From: [Rupert, Judson](#)
To: [Stein, Stephen](#)
Subject: RE: WPR20LA144 -- JPI700 & Horizon Instruments P-1000 -- preliminary report
Date: Thursday, March 25, 2021 10:29:47 AM
Attachments: [image003.png](#)

Figure 4: Plot of JPI EDM 700 data for the final portion of the accident flight recorded on May 13, 2020.

WPR20LA144
Electronic Devices Factual Report, Page 6 of 9

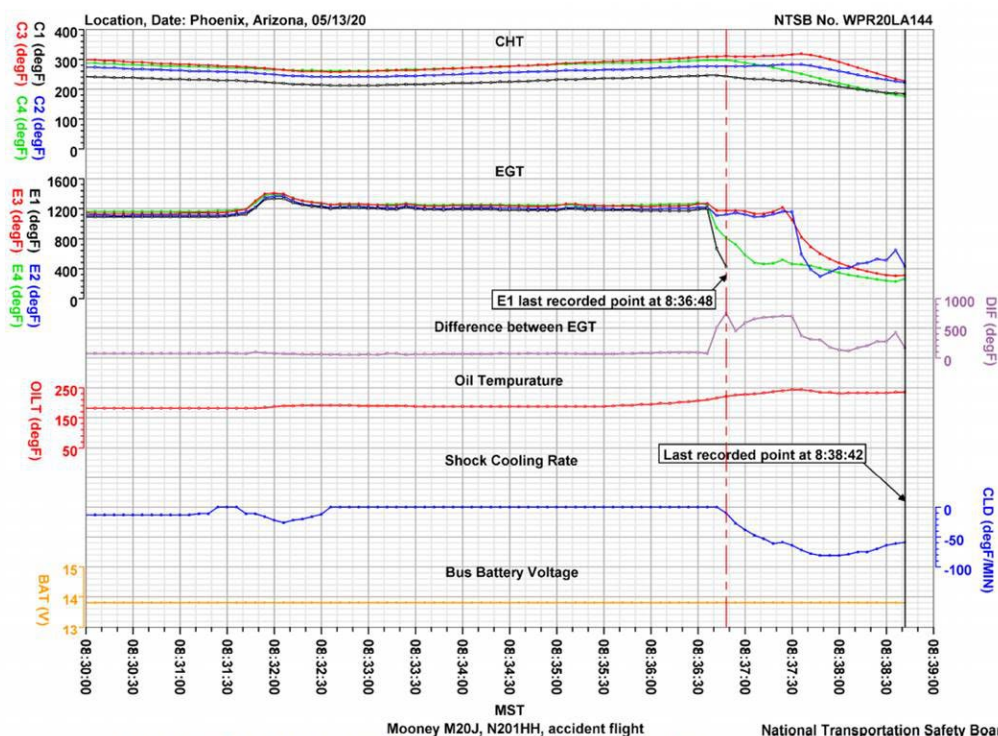
I'm re-reviewing the JPI results and was wondering since all the damage seems to be around cylinder no. 4 and subsequently cylinder no. 3, any reason why the JPI results would show cylinder no. 1's EGT reading drop around the same time as no. 4?

- 2 If you look at "final portion" the engine oil temp starts to rise at 08:35:30, so I'm wondering if this seems excessively high to you. Unfortunately we don't have oil pressure, but maybe you can tell me your thoughts regardless. It's not excessively high but you can see the gradual increase in the oil temp that tells me that more than likely at time 08:35:30 the badness started happening in the engine. Looks like cylinders 1 and 4 lost combustion starting at 08:36:45. Before the event, the oil temp looks normal around 200-210 deg.

- 1 I ve never seen shock cooling in a JPI reading and not sure what is considered normal here The May 6, 11, and 12 flights are nearly flat line under shock cooling
- 2 If you look at “final portion” the engine oil temp starts to rise at 0835:30, so I m wondering if this seems excessively high to you Unfortunately we don t have oil pressure, but maybe you can tell me your thoughts regardless
- 3 EGTs and CHTs don t look bad, but would like your thoughts on this as well

Firing order is 1-3-2-4, so I'm only theorizing here, but if 4 let go and the next in line was 1 to fire, it could have been effected by 4. 2 and 3 also drop at the same point but not nearly as much as 1. Once you have a broken connecting rod beating everything up, I'm not sure the intake charges are what they're supposed to be from that point forward.

Again, just one plausible explanation. The other could be one of cylinder probe location and wiring harness, are you sure the cylinder #1 trace is really cylinder #1 or could it be #3? Would not be the first time I've found connections crossed on the same side of the engine.

- 3 EGTs and CHTs don't look bad, but would like your thoughts on this as well. Agree, CHT and EGTs up until the time mentioned above all look normal for that installation. No outliers in EGT spread and standard spread in the CHTs.
